**SUBJECT:** C814-2012-0160 / 211 South Lamar Boulevard PUD

**ZONING CHANGE REVIEW SHEET**

**CASE:** C814-2012-0160  
211 South Lamar PUD

LAND USE PLAN

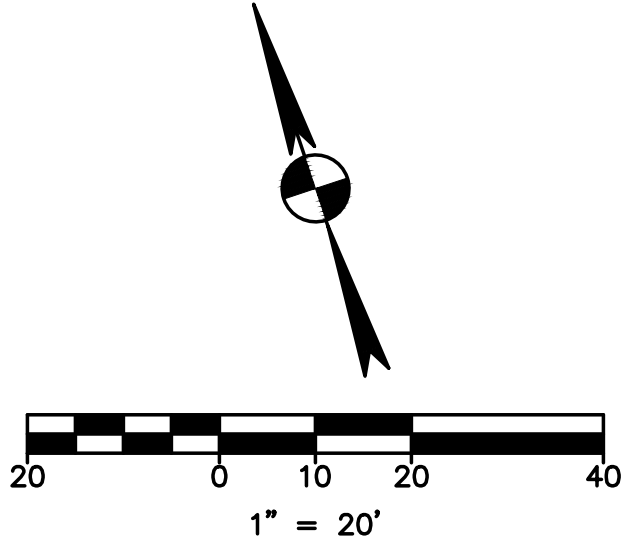
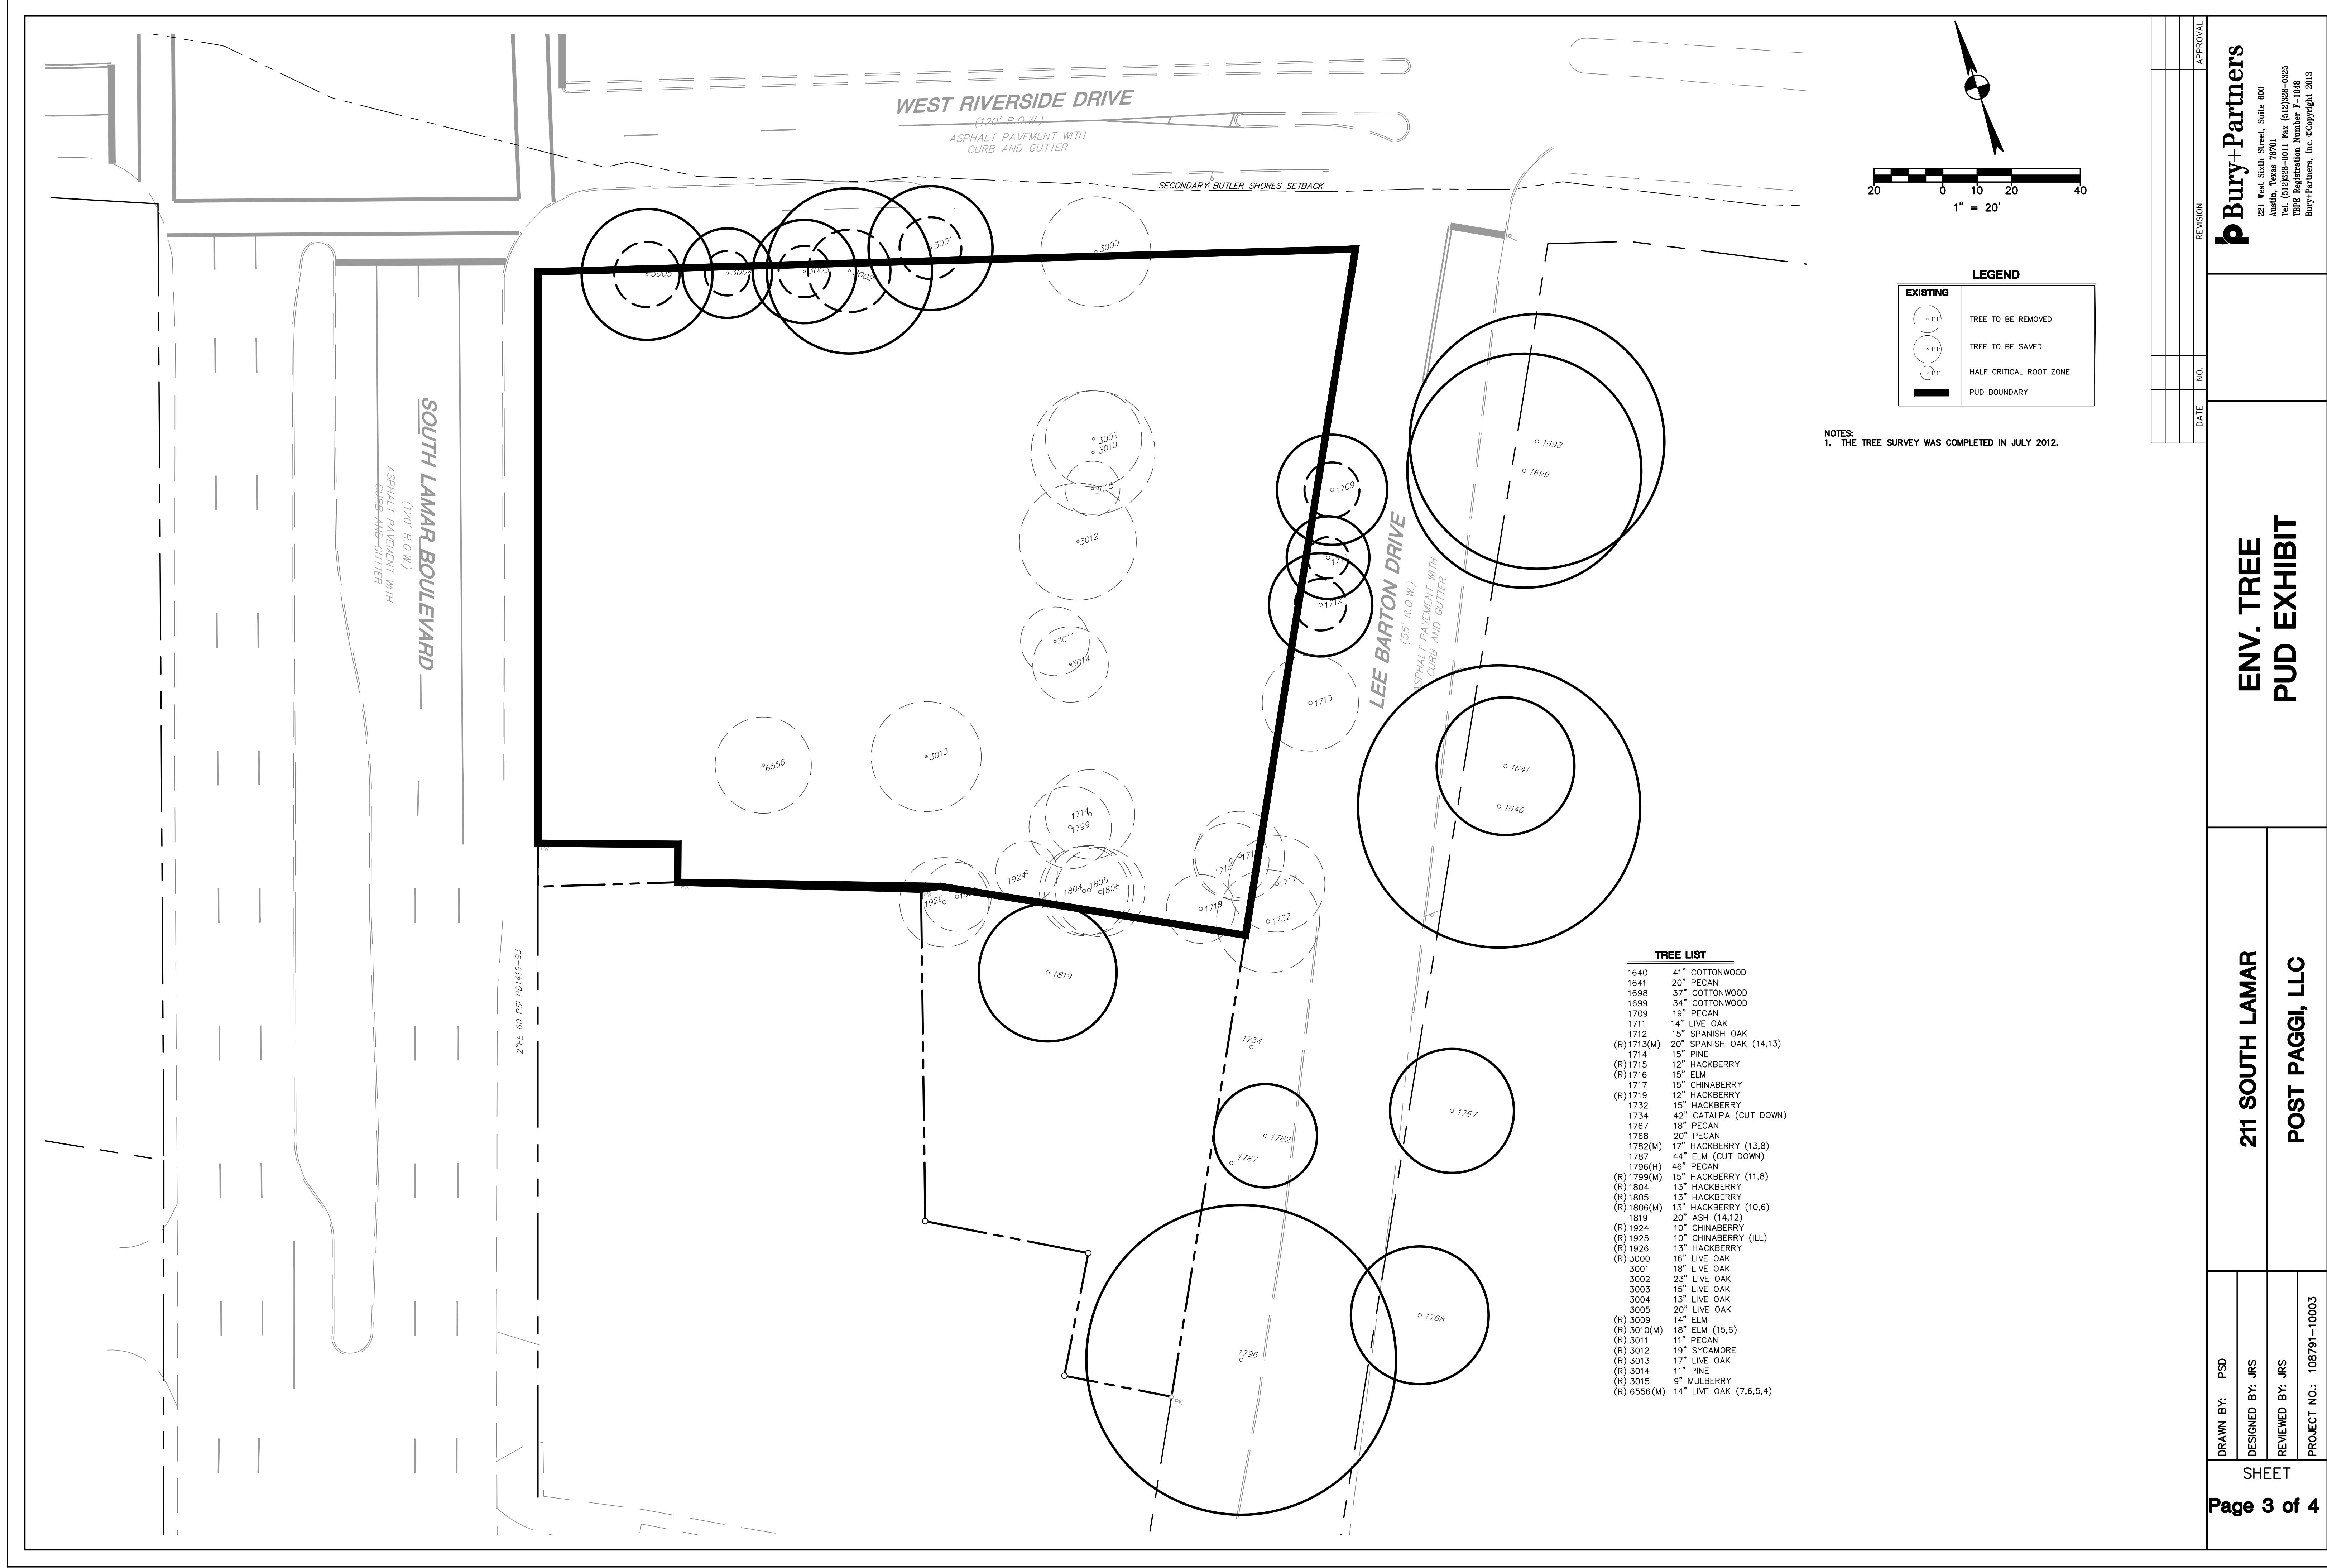
- h. Note # 32: Please highlight trees in Sheet 1 schematics. See also 6a, below.
  - i. Note # 33/Variance to TCM9.3.0 #3: Is this a variance to zoning requirements or to site-planning requirements? If it is appropriate to consider at the rezoning stage, then provide the documentation from Transportation (see reviewer note #7) concurring with the proposal. If this is NOT a variance to the zoning code, but associated with site-planning, then please remove from plan sheet and table of CS variances.

- g. **Noted.**
- h. Note # 32: Please highlight trees in Sheet 1 schematics. See also 6a, below.
- h. **A new sheet has been added to the Land Use Plan clarifying tree preservation.**

**ENV. TREE  
PUD EXHIBIT**

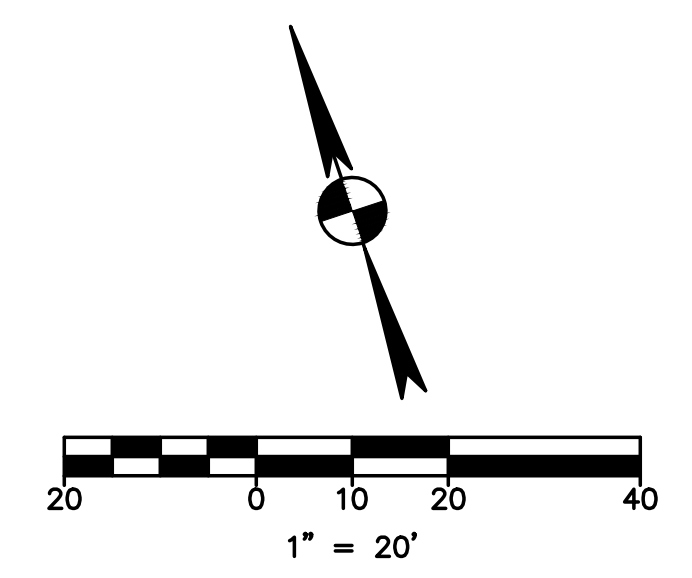
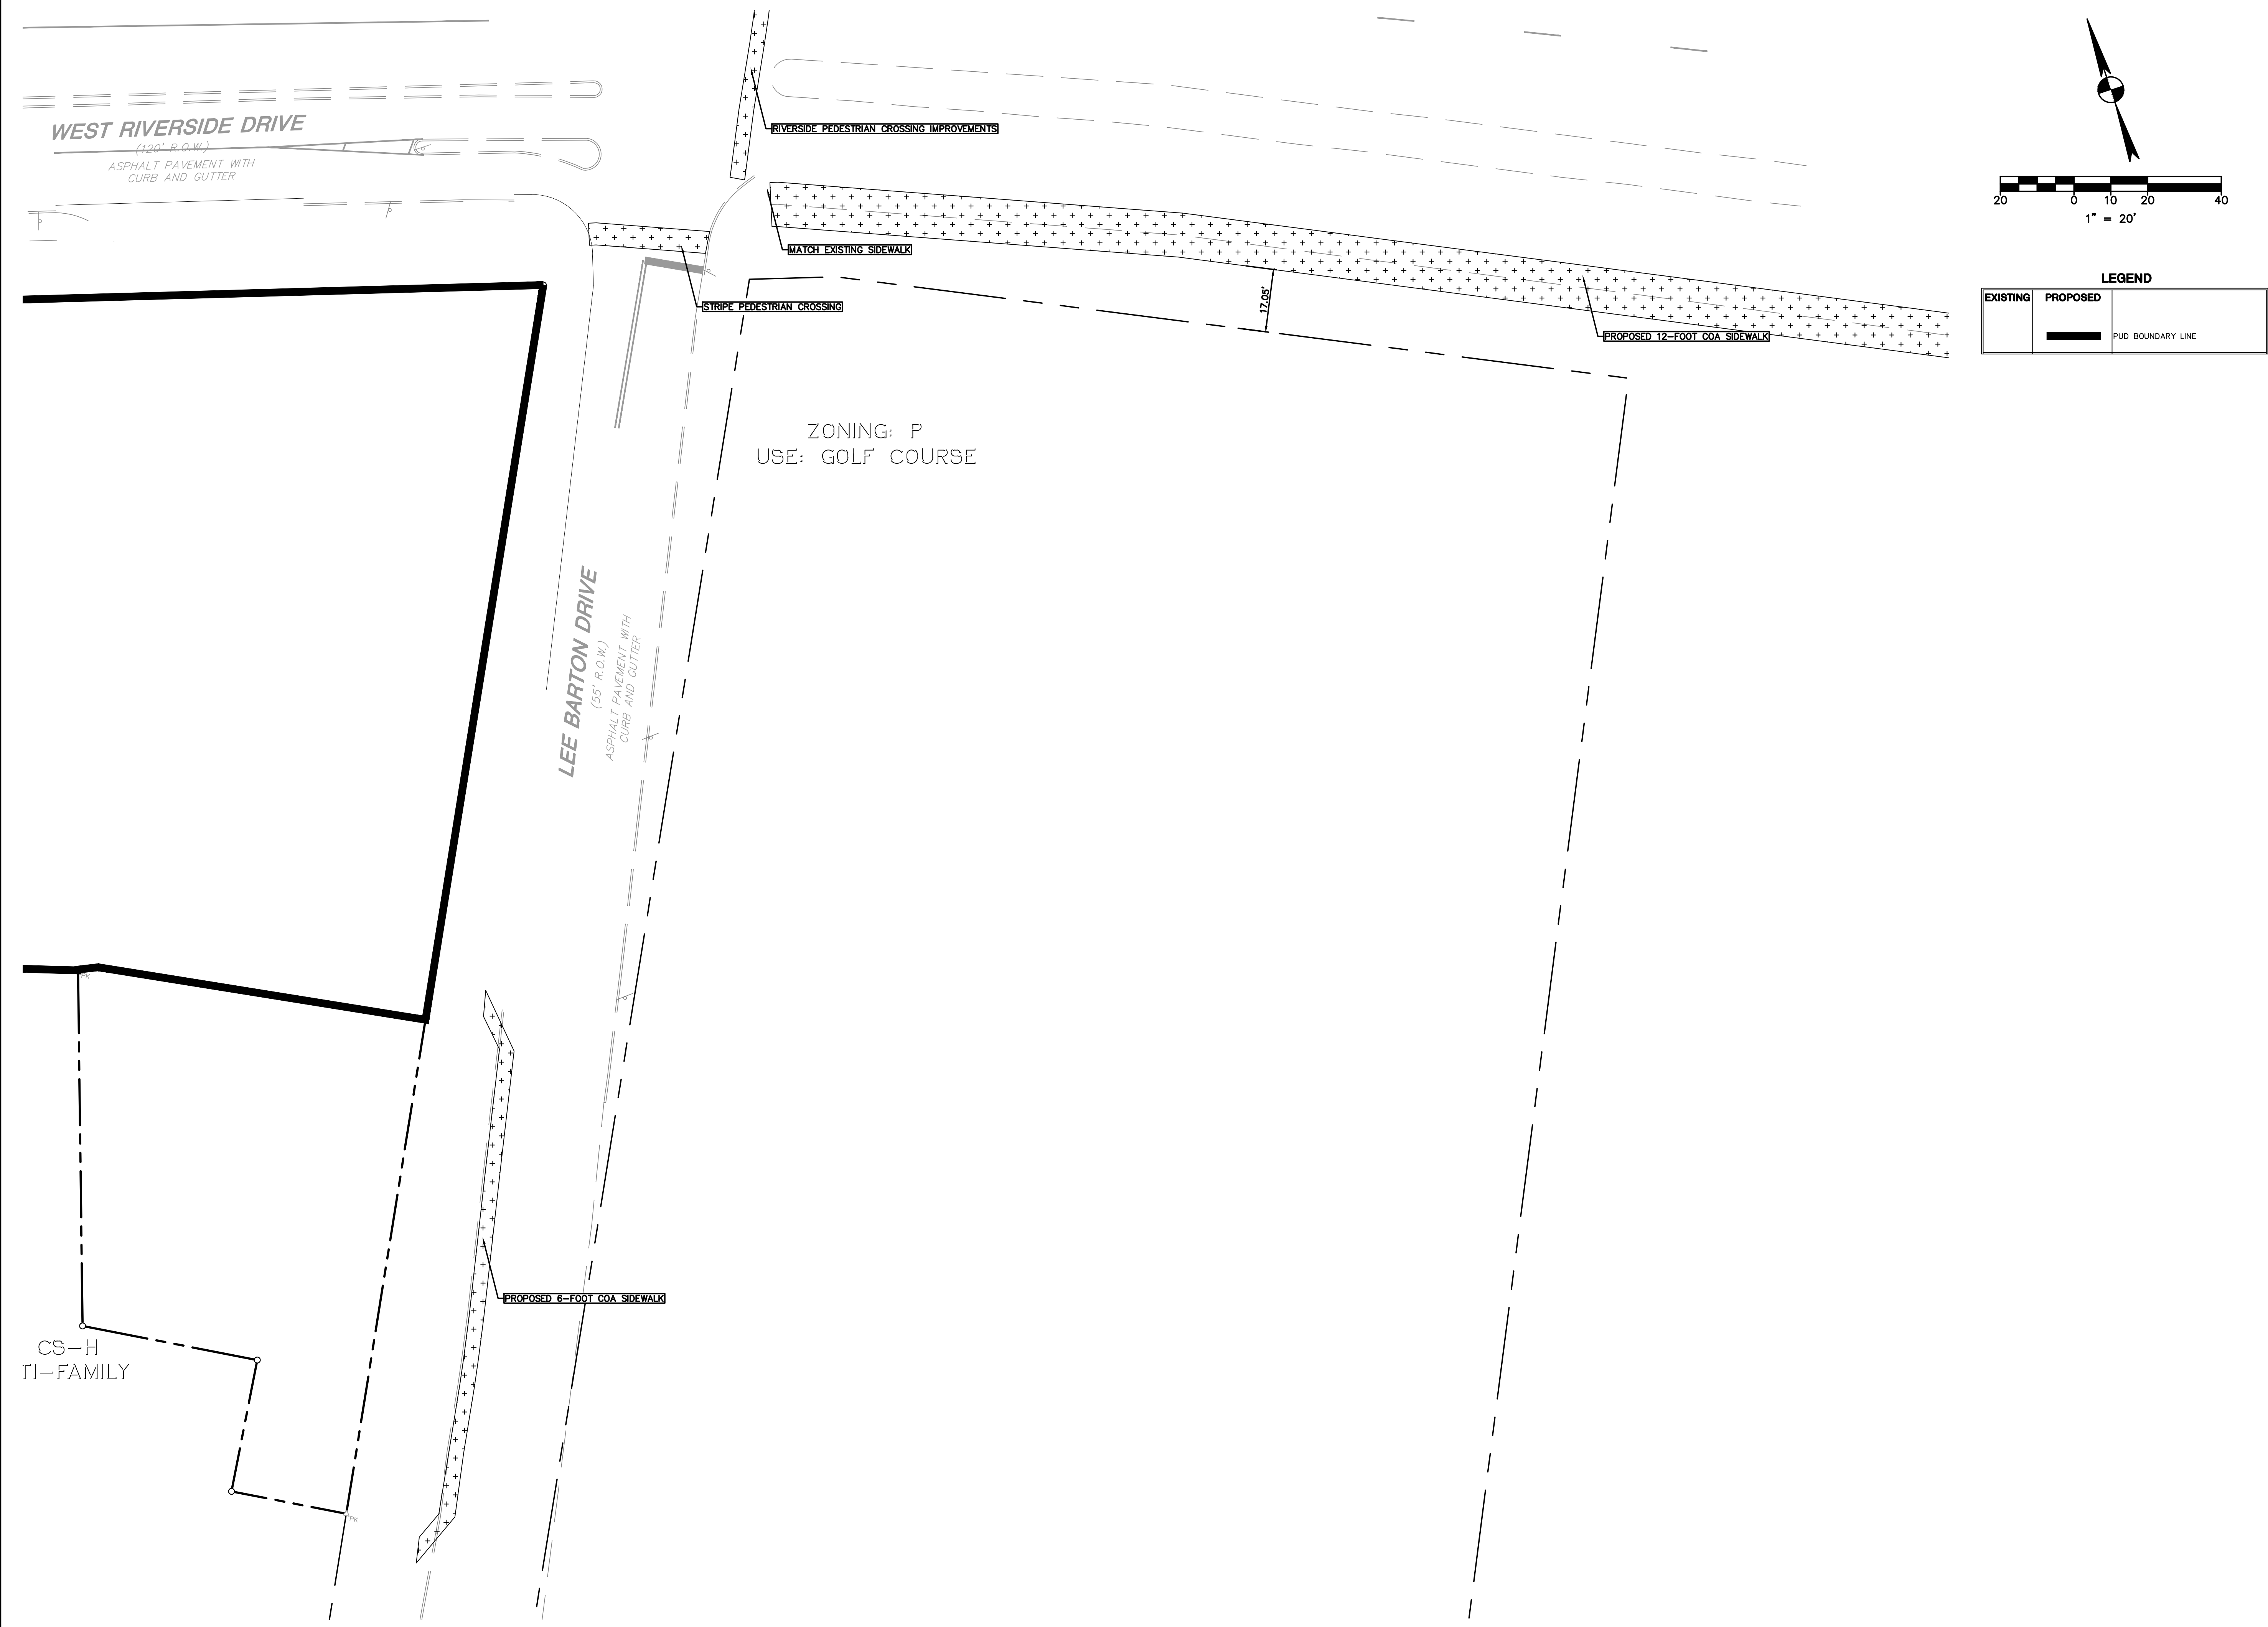
**UPDATE #1 Note # 32 addresses the tree preservation criteria required to preserve trees in the PUD. The Env. Tree PUD Exhibit, sheet 4, shows tree #1709 to be removed in the list when it is supposed to remain, and it shows tree 1732 with a 50 ft CRZ instead of a 30 ft CRZ as stated in the tree survey list. Please correct these inconsistencies. This comment can be cleared informally.**
